No. **2000-1**

**SUBJECT: Backrest Lock Lever Guides
Premature Rust**

No. **2000-2**

SUBJECT: Belt Guard Bracket

1. Involved guide

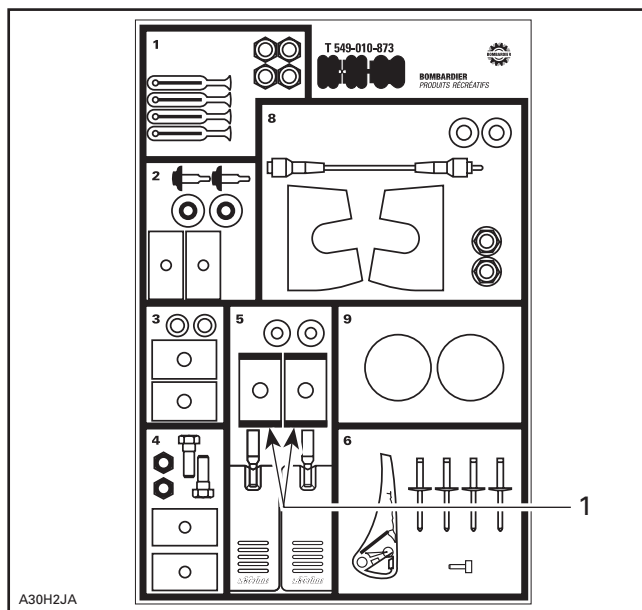
Backrest lock lever guides will prematurely rust, not having been, beforehand, treated against rust.

Replace guides in the predelivery kit, section 5.

While performing predelivery inspection procedure, simply pull out predelivery kit from the crated snowmobile and exchange faulty guides with new ones.

1. Rivets to be drilled
2. Footrest
3. Driven Pulley

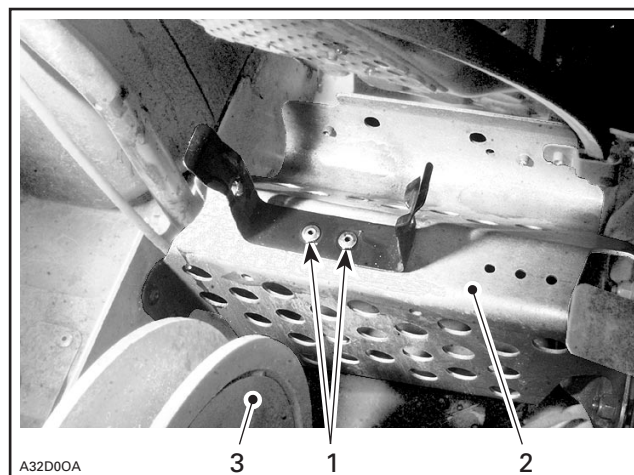
On some units, belt guard rear bracket is too brittle and may break when belt guard is installed or removed.

Drill both rivets securing rear bracket.

Remove bracket and keep reinforcement plate.

Make sure surface of footrest receiving belt guard bracket is plane.

Secure new bracket and reinforcement with rivets (P/N 390 402 200).

1. Shaft
2. Ring
3. Nylon packing already there
4. Levers

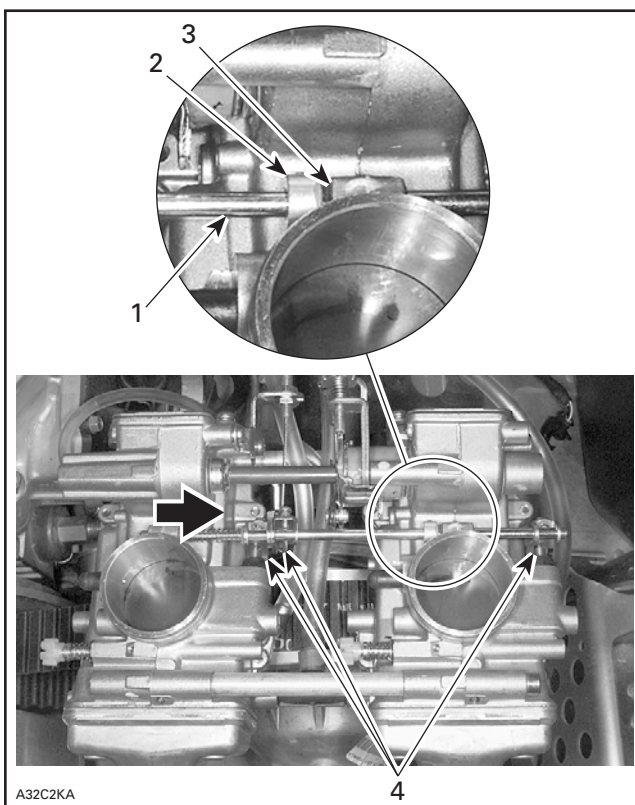
Subject B only) Carburetors enricher plunger shaft "E" clip may come out of position and fall off which could cause damage to plungers.

Loosen all 3 lever screws so that shaft can slide freely.

Proceed with **new shaft** installation by inserting it slowly, leaning and pushing on old shaft.

Make sure proper shaft end is inserted first and in the proper direction, starting from MAG side carburetor towards PTO side carburetor.

Before reaching PTO side carburetor, insert **new ring**, secure same with **new set screw** properly indexed, (apply Loctite[†] 243 (blue) on set screw) and **ensure to keep nylon packing which is already there.**

Push shaft till the end, index and tighten all 3 lever screws.
